CF Industries, Inc.
Plant City Phosphate Complex

Subject: DEP File No. 0570005-019-AC; PSD-FL-339
Sulfuric Acid Production Increase, Plant City Phosphate Complex

Figure 1

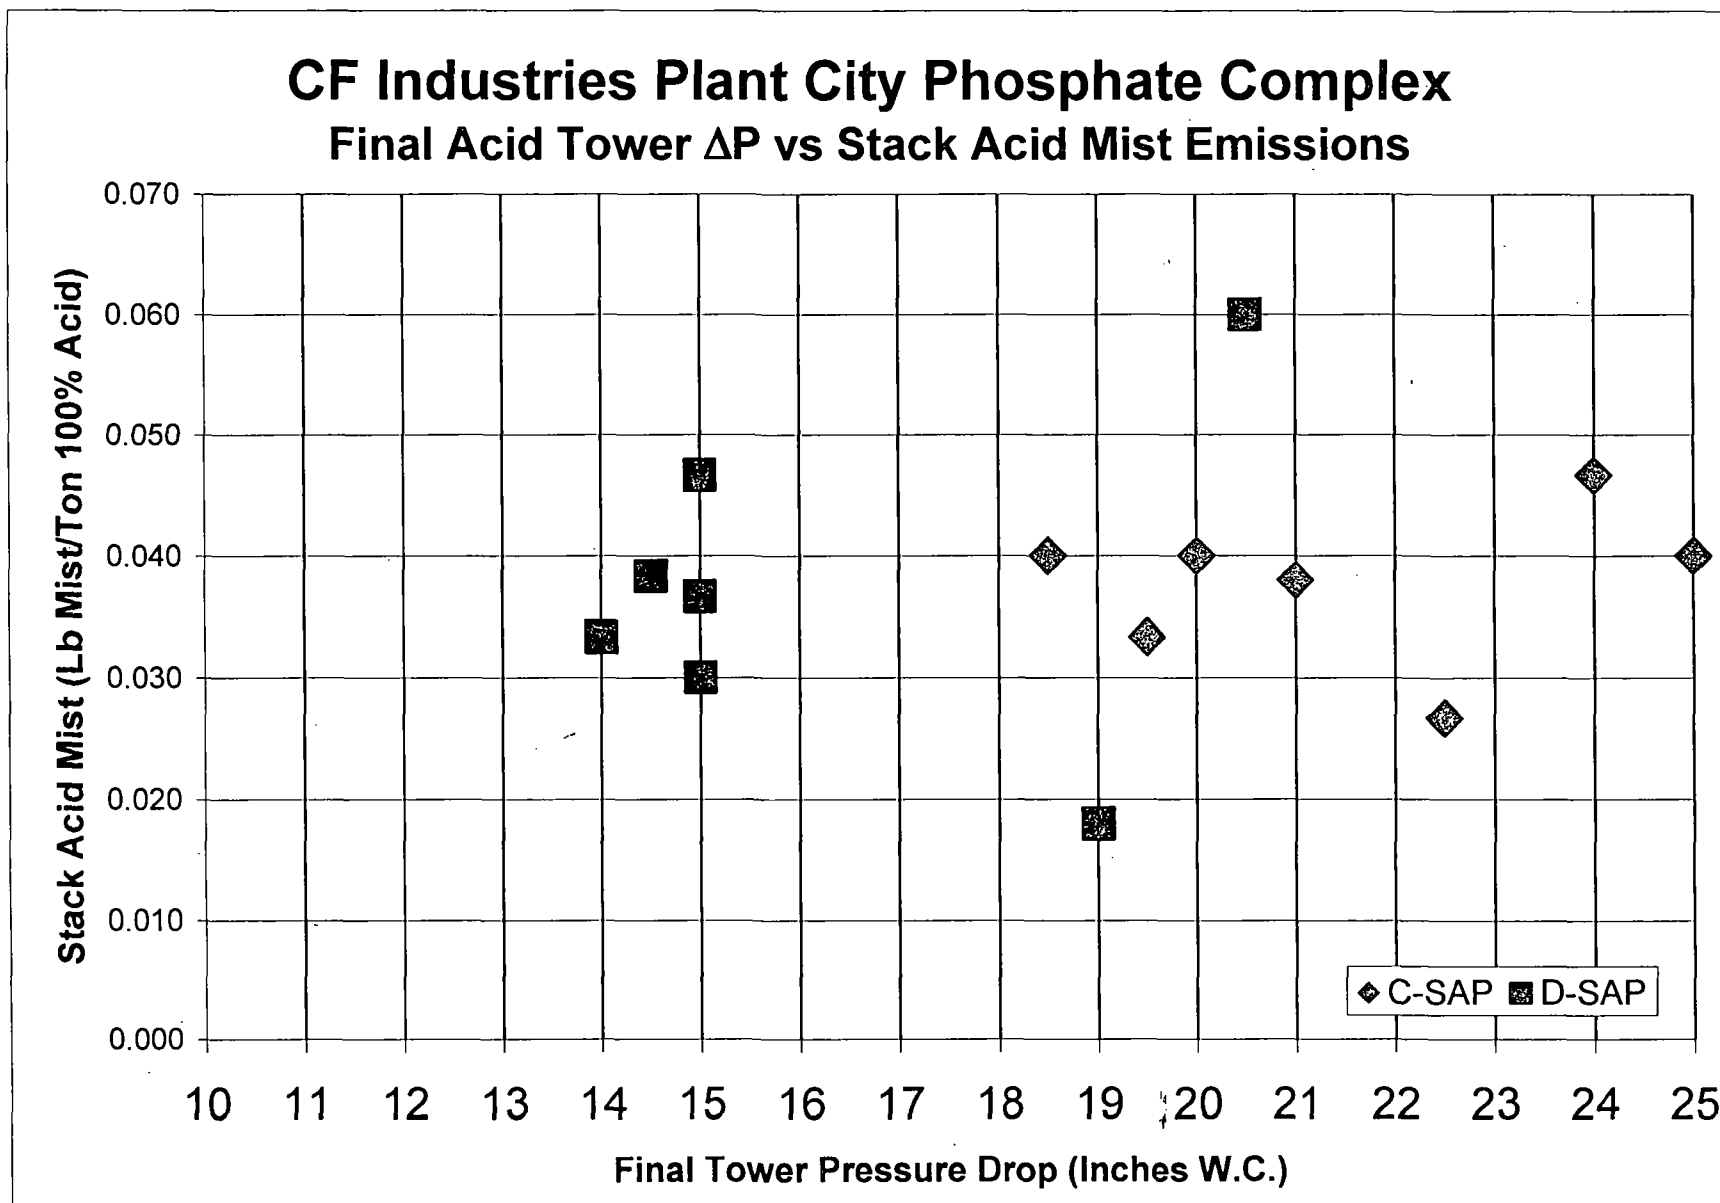
1. **On Page 4 of 15, it states that "the packing in the remaining four absorption towers may be replaced with "in kind" packing as the current packing exhibits high pressure drop and requires replacement." Do we have any timeline from CF as to when this will occur? What impact does the high-pressure drop have on performance with respect to emissions to the atmosphere?**

The high pressure drop has no relationship to emissions as illustrated in the attached Figures 1 and 2, which show annual compliance test data for "C" and "D" Plants acid mist and SO₂ emissions versus the Final Tower pressure drop. Sulfuric acid mist (SAM) is removed from the gas stream by de-misters located downstream from the tower packing, and SO₂ is removed by chemical conversion to SO₃ at a location upstream of the towers. Changes in pressure drop within the normal range of operation are not sufficient to affect the emission rates.
